AB 3826

BUSINESS OF THE CITY COUNCIL CITY OF MERCER ISLAND, WA

VETERANS RECOGNITION PROJECT- FINAL DESIGN AND FUNDING APPROPRIATION

VETERAN'S MEMORIAL PROJECT

VETERANS RECOGNITION PERGOLA AT MERCERDALE

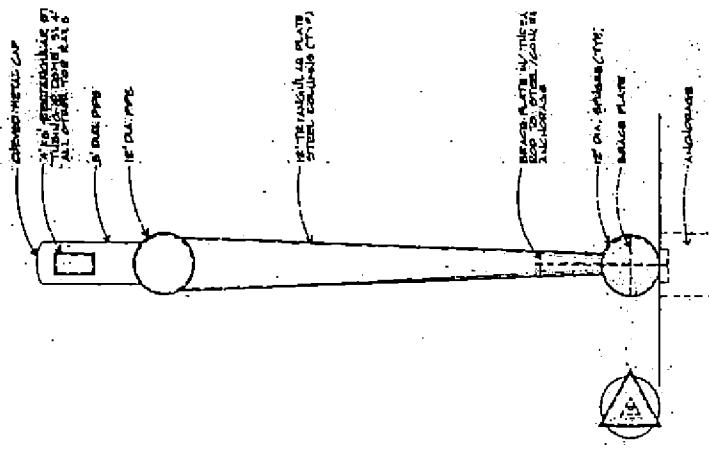
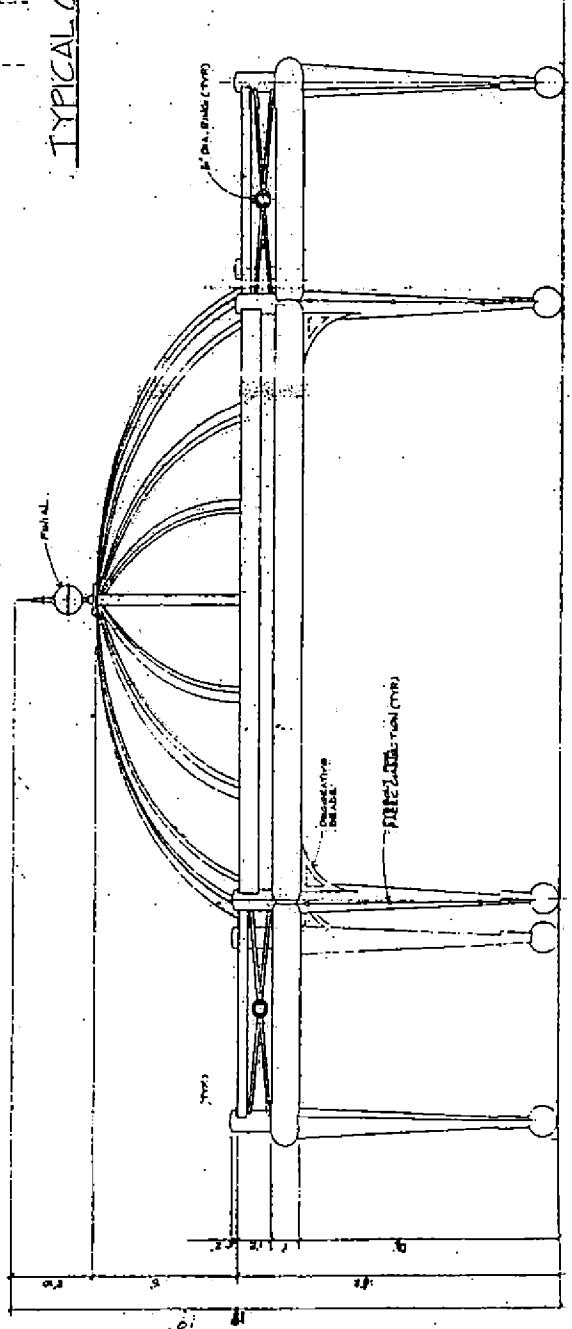
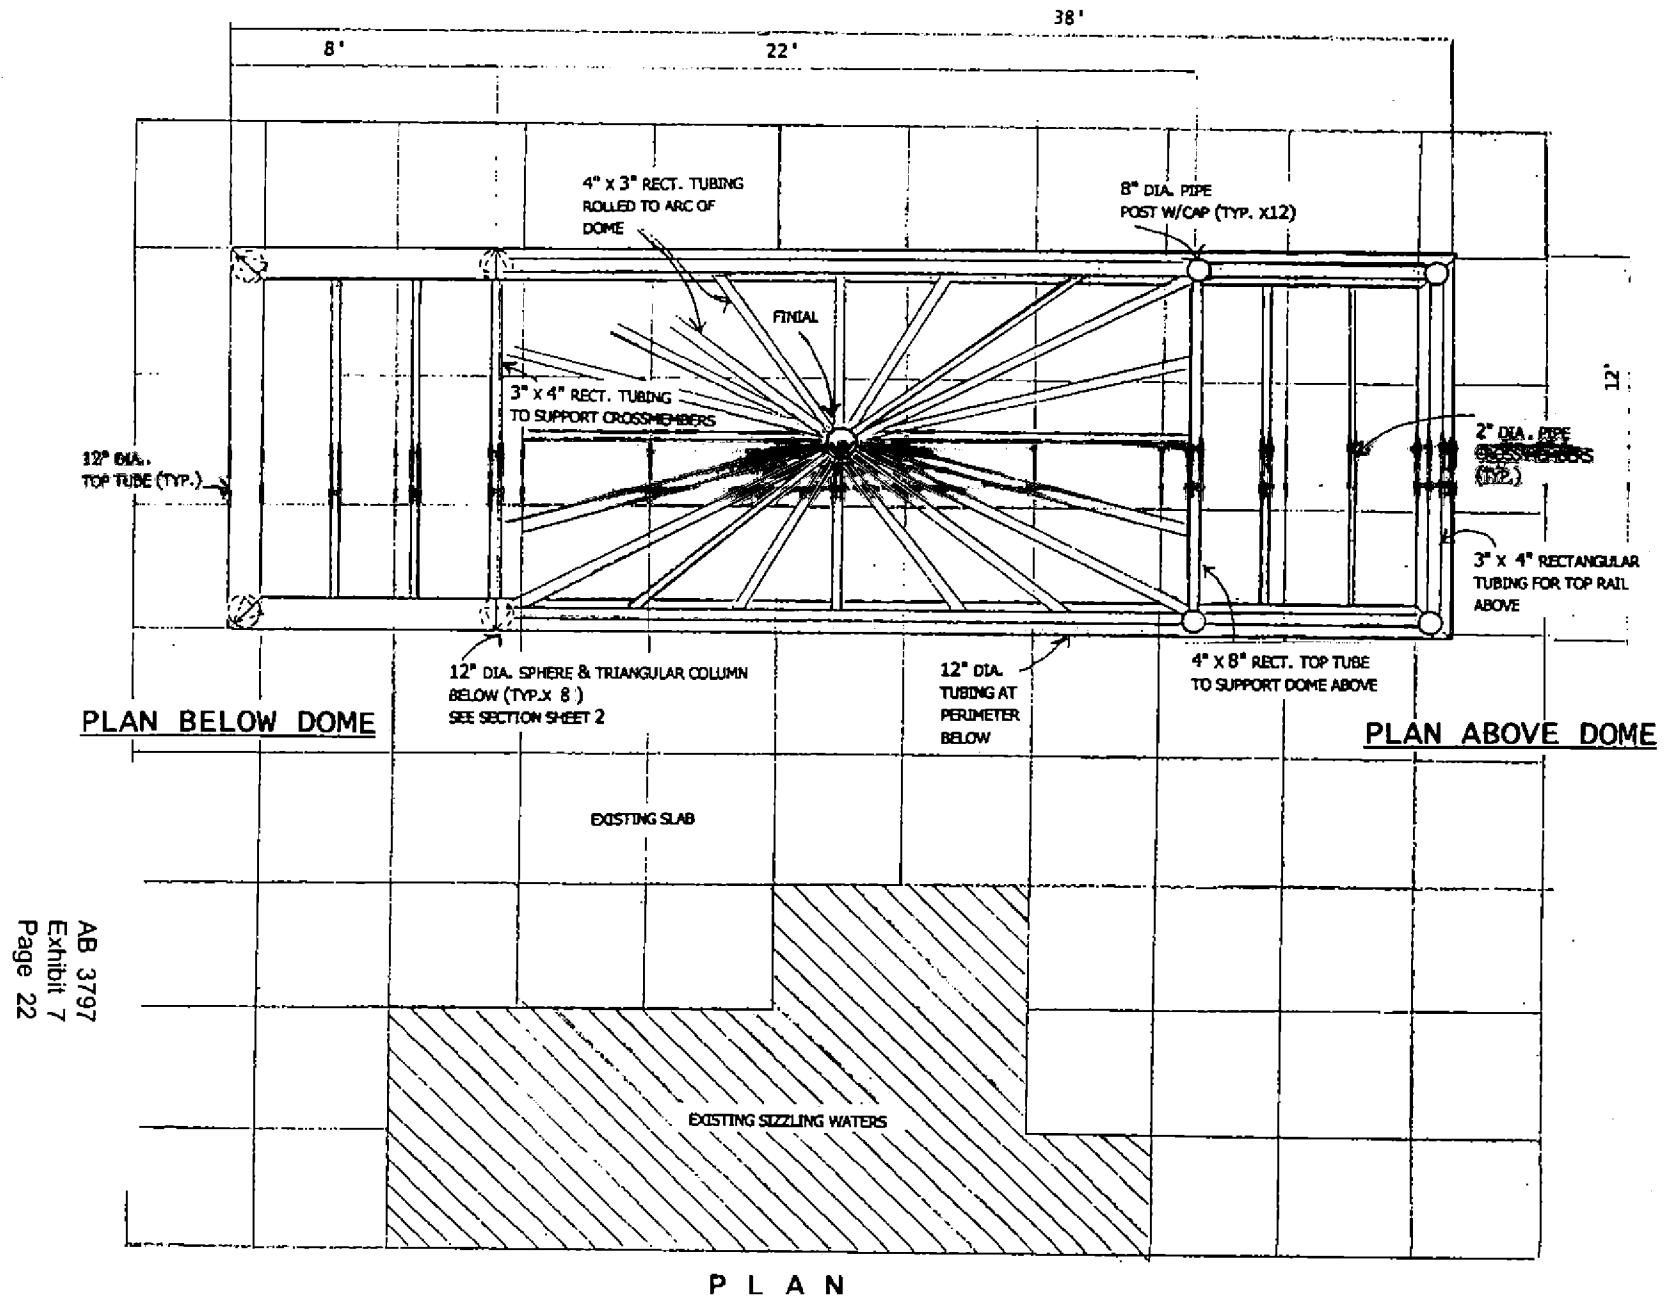
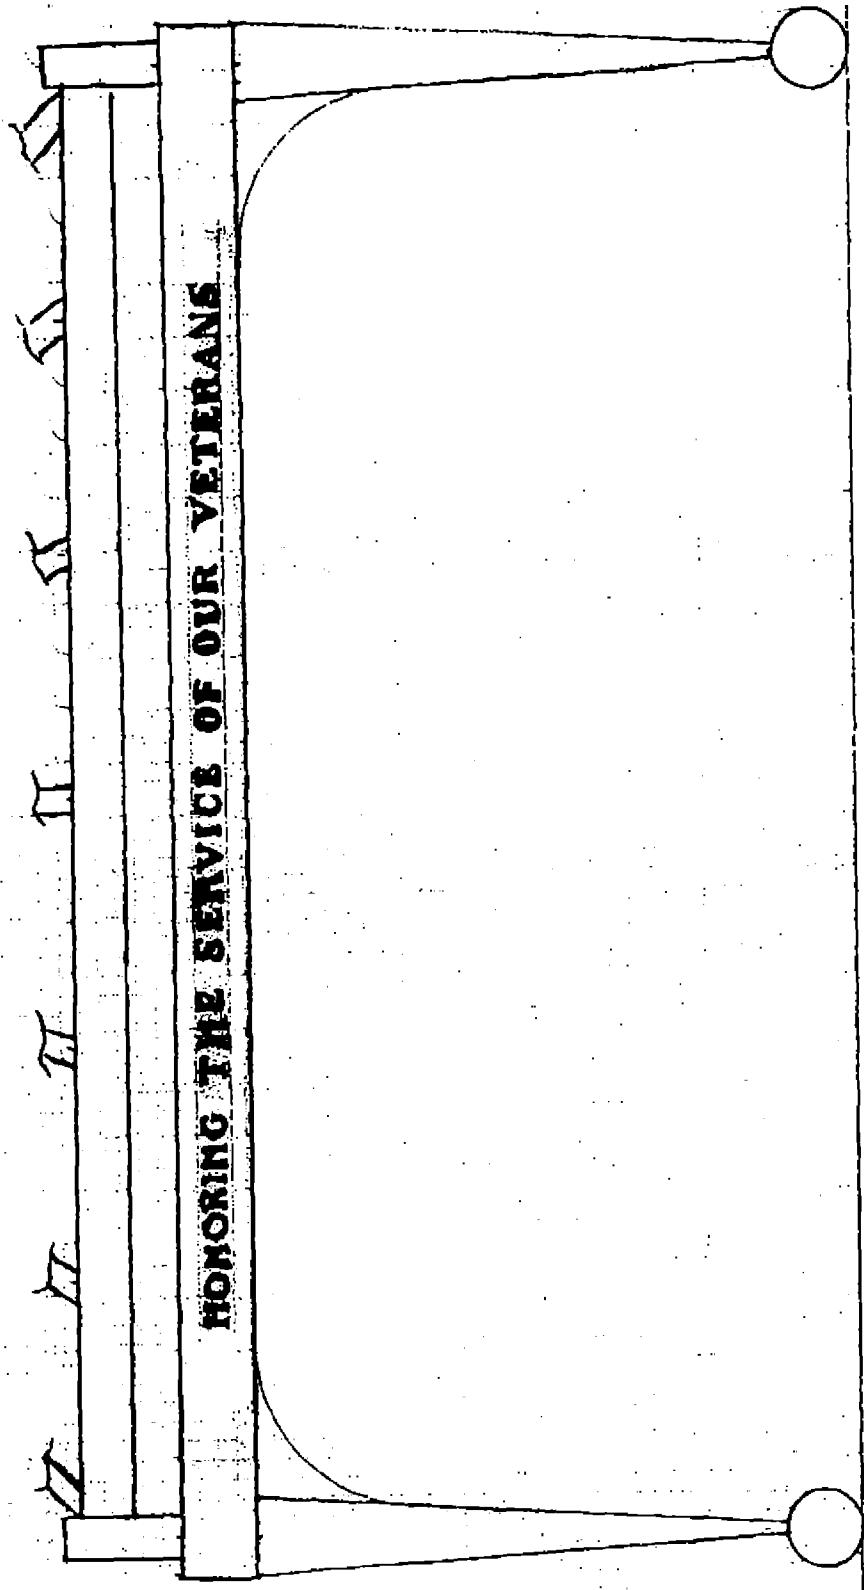
Dimension I must tell you that 600 square feet is a typical minimum by most standards. Your proposed floor plate of 22' x 12' may be appropriate for 2 rows of 8 performers plus a drummer. (maximum). Given that the 'Stage' floor is on grade, there is flexible room here by simply extending the available space out beyond the front or back of the actual stage area. The 'wings' on each end will allow for expansion although the use is limited by the columns of the structure, which are close to each other. With a 9 foot clearance, 11 foot and 17 foot total height, there is some ability to erect a temporary platform within the Plan of the Facility for some needed site line improvement.

The floor area of the stage should be a direct result of the use. The existing design reflects todays stated 'Program'; but remember it does not allow for flexibility in the future.. You will not be providing a space for most dancer groups or an orchestra or a 'Big Band' performance. (for example 25 -30 performers). We know that the use may change in the future. The irony here is that, the more successful the structure is, the more uses will appear in the future wanting to utilize the structure.

Site Lines I am sorry to be a nudge on this one (and I know there are other important considerations) but please be sure everyone understands that a stage on the level of the audience is limiting site lines in terms of audience depth. People cannot see over other audience members who are standing or even seated in typical lawn furniture in front of them. I would raise the stage platform. If you are sure (as stated) that there has not been in the past a raised stage nor will there be a need in the future then you are quite right in providing for the performance space to be on grade. While site lines are limited, you do get the advantage of flexibility, cost savings and simplicity. As stated above you can erect a temporary platform (of limited height) should the need arise.

Stage Roof The roof over the stage does not allow for performances in the rain (obviously). Your fabric roof, if well designed will, however, allow for the musicians to confidently set up during the day (when it is raining or threatening to rain) for a later performance if the sky clears. It also insures that valuable instruments are not damaged in a sudden downpour. This means you can operate when the weather is threatening. This will vastly improve the chances of performances when the weather is 50/50.

Lighting Consider at least basic lighting for the performers. this may enhance the beauty and the practicality of the facility even if full night use is not anticipated. I have never experienced summer light in the north and West Side of a time zone so I cannot respond to reports of daylight at 9pm. I am thinking more of light for aesthetic effect and again, flexibility of use.

Backdrop The backdrop will also be the fabric like that on the overhead. The legs of the pergola are designed to have hidden rings for toggles to connect the sail material.. This will allow for where the necessary equipment, trash, backup materials, props, instruments, costumes will be. If any drama is contemplated, the backdrop gives you a backstage, a stage left and right. If you have multiple performing groups, they have a place to be while waiting until their turn.
